Agenda Item #1

Application 2024-3-CA

68 Bradford Ave

Remove and replace existing siding with fiber cement lap siding. Replace windows on all elevations except for façade.

5. View of south entrance and south elevation.

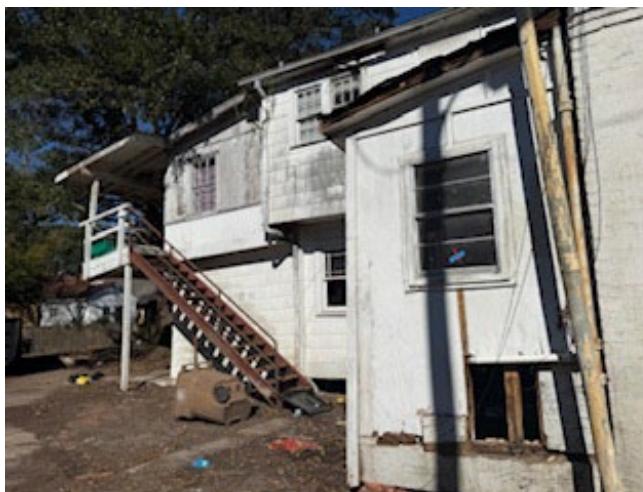
The *Guidelines* state that on non-primary elevations, alternative materials that match the style and detail of the original may be used. (5.7) Re-cladding the side and rear elevations in a uniform fiber cement board and batten would be a more sympathetic alteration to what is currently extant. Additionally, fiber cement siding has been approved for use in Mobile's historic districts. In regard to replacing the original wood lap siding on the façade, the *Guidelines* clearly direct to preserve key walls of a historic building, their original materials, and further states that original materials be used to replace damaged materials on primary elevations where possible, and to replace only the damaged areas. (5.3, 5.4, 5.6) The applicant has submitted photos showing the condition of the façade's existing wood siding which denote areas of significant damage and deterioration.

In consideration of the proposed window replacement, the *Guidelines* direct to preserve and repair windows that are in repairable condition, and when they are not repairable, to match the replacement window to the original. (5.20) The applicant completed a window survey, assessing the condition of the windows intended for replacement on the non-primary elevations at 7 Hannon Avenue. The survey and visual inspection reveal that the existing windows are not in a significantly deteriorated or unrepairable state. The proposed replacement windows would be aluminum-clad wood windows, which is an acceptable window material under the *Guidelines*. Similar to the cladding material at 68 Bradford, the existing windows are a mix of original and replacements, and vary in size and light configuration. The replacement windows' light configuration would be a period appropriate pattern and would contribute a more uniform and planned appearance to the non-primary façades. (5.21)
